**Addendum No. 2
January 20, 2023**

Project: Baltic High School Addition
Baltic, South Dakota
Arch Project No. 2957

Architect: Architecture Incorporated

SECOND FLOOR FRAMING- AREA G
1/8" = 1'-0"

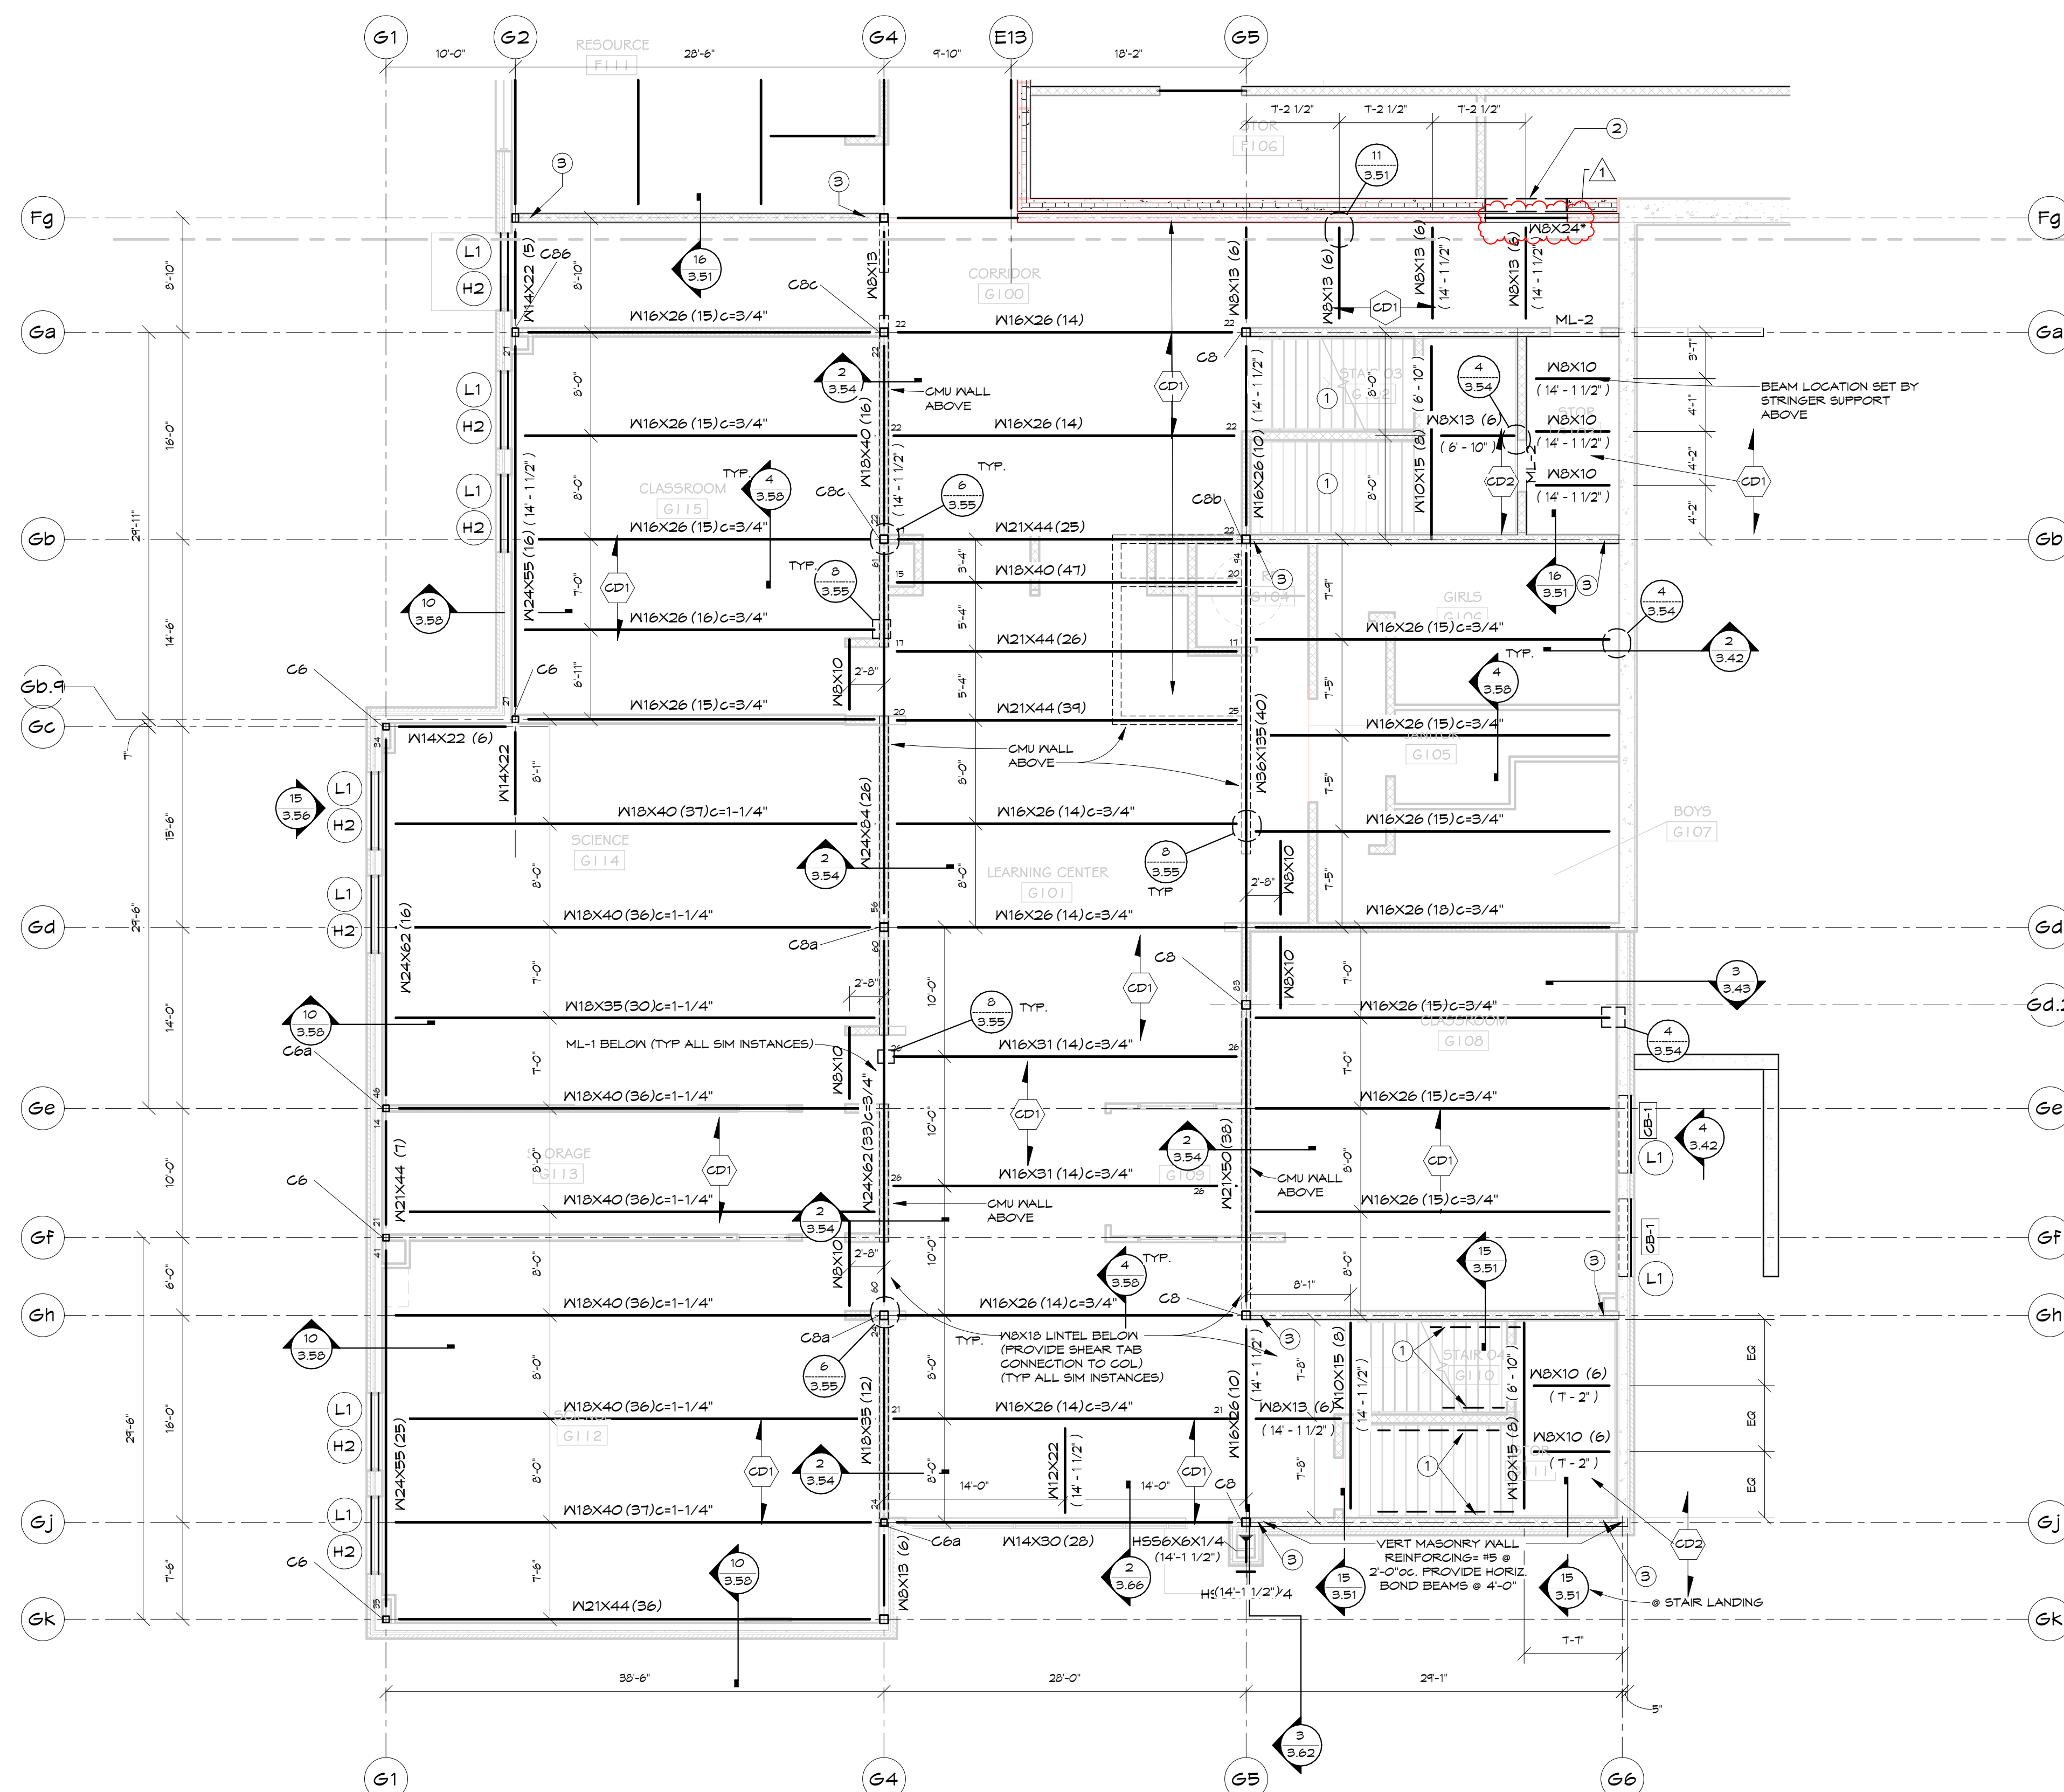
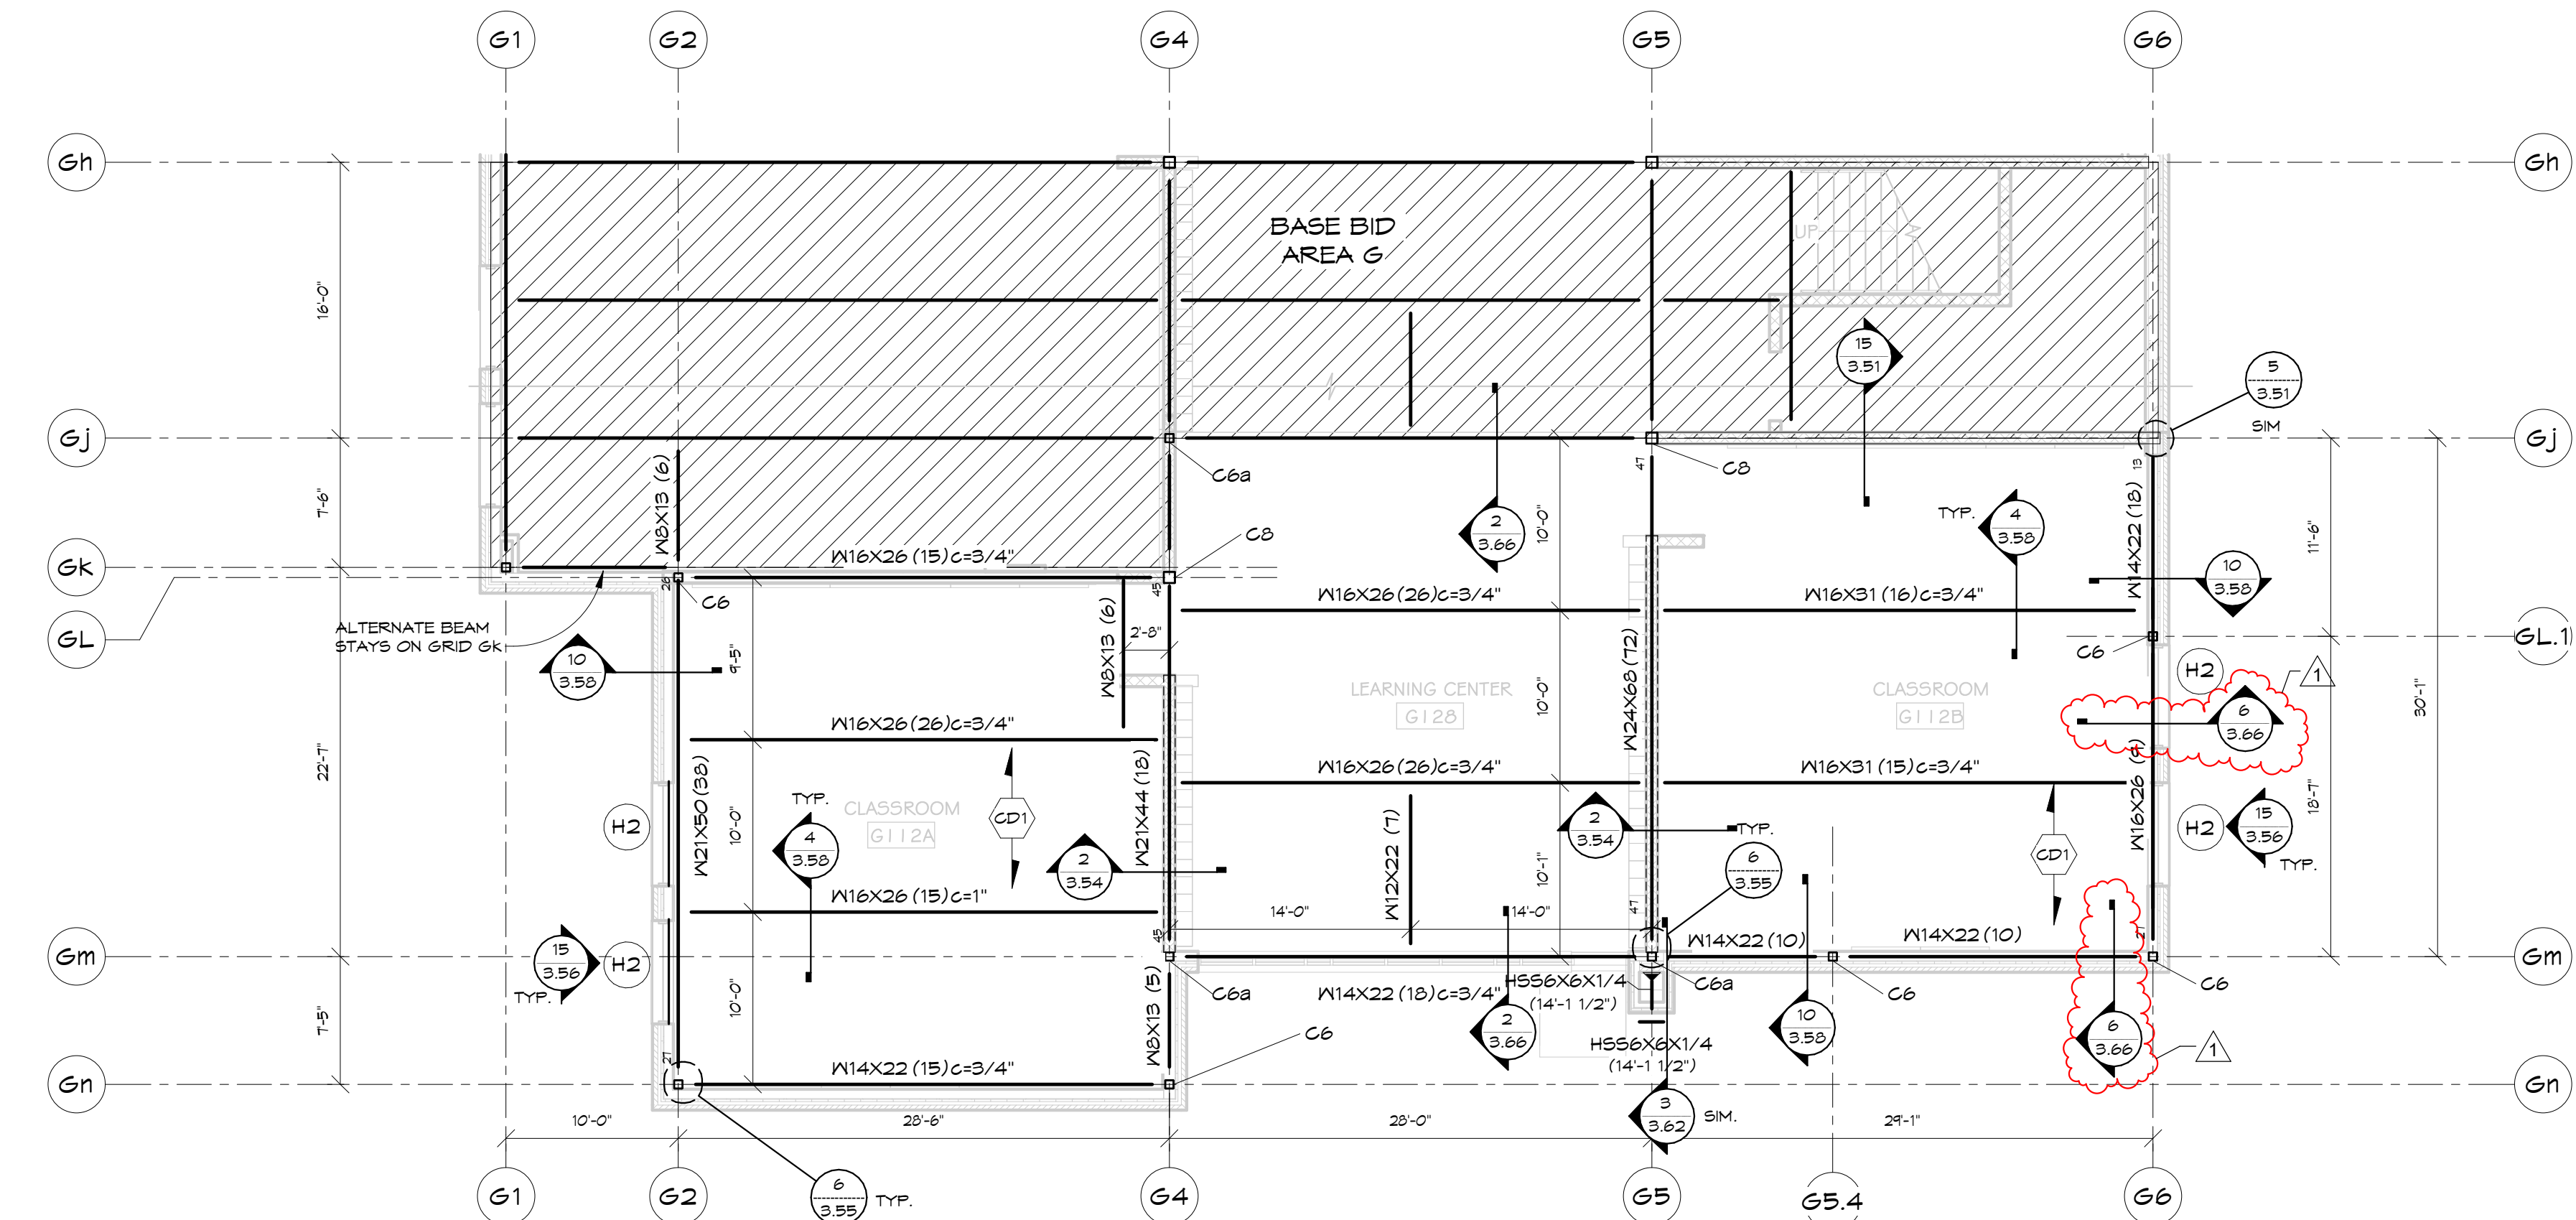
- a) Add lintel beam size designation at CMU wall opening along gridline Fg where clouded on revised structural drawing Sheet 3.20-2G.
- b) Add detail reference 6/3.66 at east and south exterior wall of CLASSROOM G112B (ref: ADD ALT area) as shown on revised structural drawing Sheet 3.20-2G.
- c) Reference revised drawing Sheet 3.20-2G, revision dated 1-20-23, attached to the end of this addendum for structural changes listed above.

ROOF LOW/MEZZANINE FLOOR FRAMING- AREA H
1/8" = 1'-0"

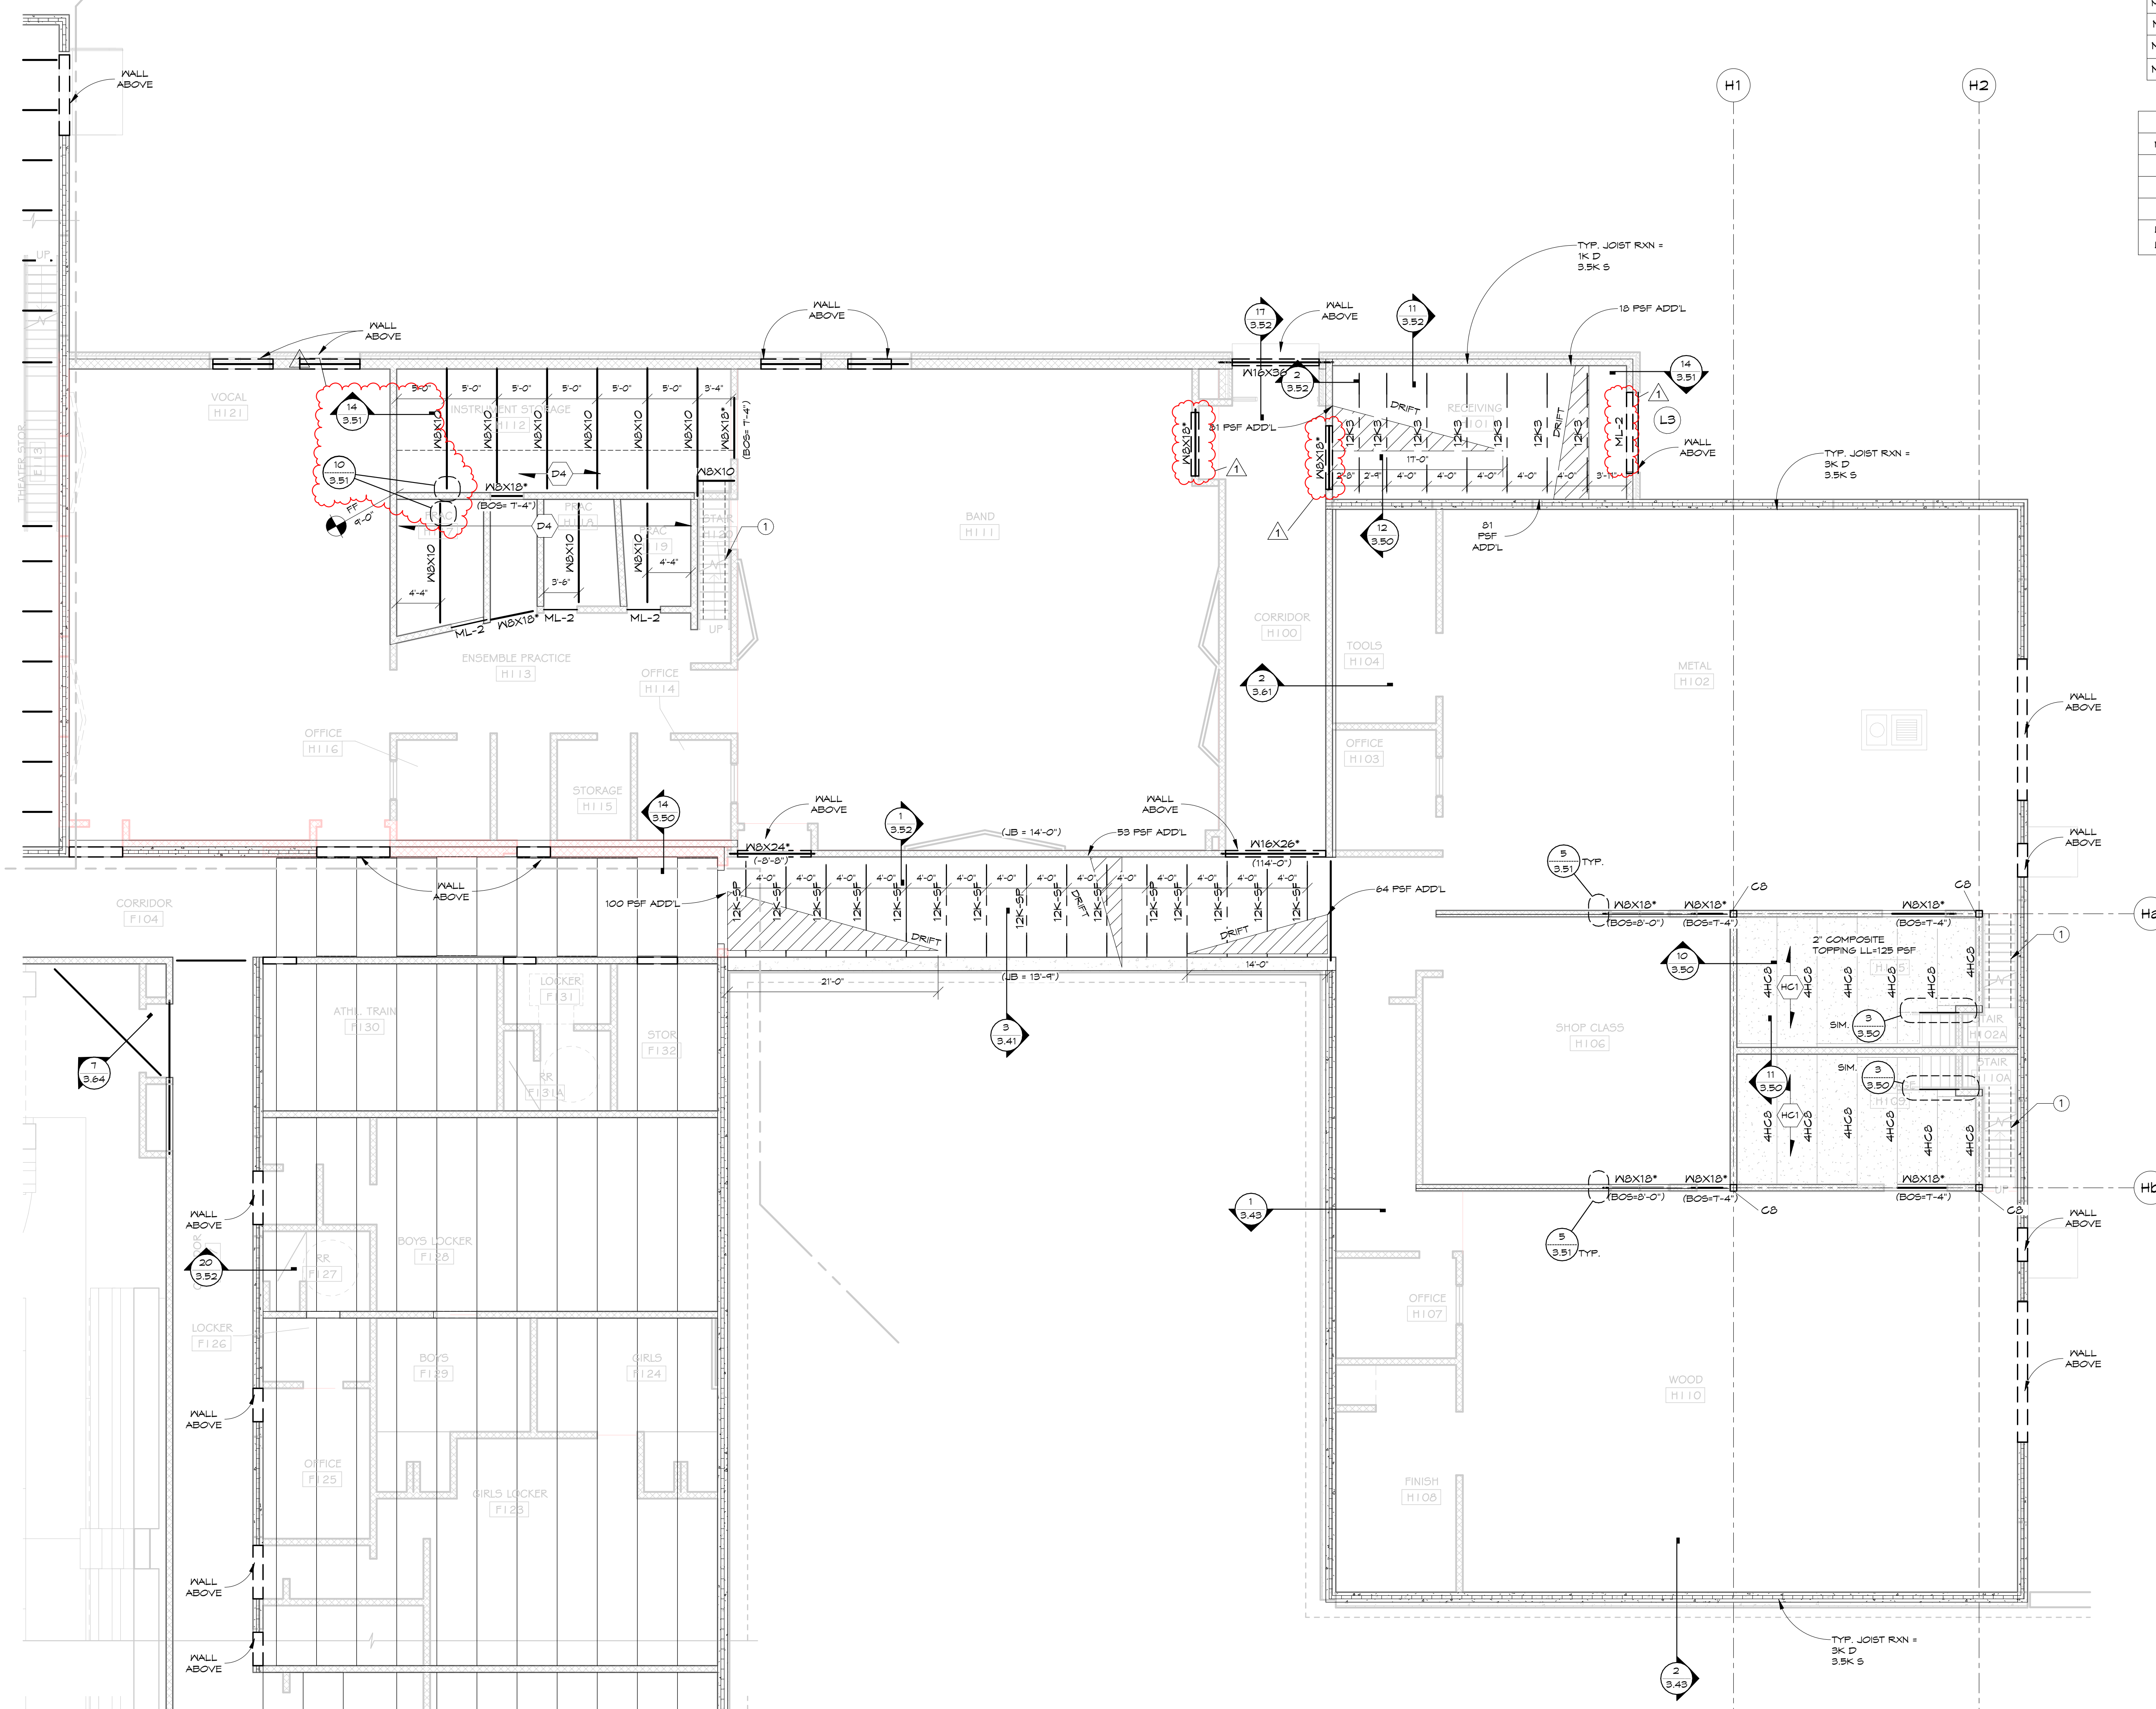
- a) Add lintels around RECEIVING H101 per clouds on revised structural drawing Sheet 3.20-2H.
- b) Change detail references at INSTRUMENT STORAGE H112 & H117 per clouds on revised structural drawing Sheet 3.20-2H.
- c) Provide masonry bond beam lintels over door openings 113-1, H114, H115, H116, H121-1 & H121-2.
- d) Provide masonry bond beam lintels over borrowed lite openings in Office H114 & Office H116.
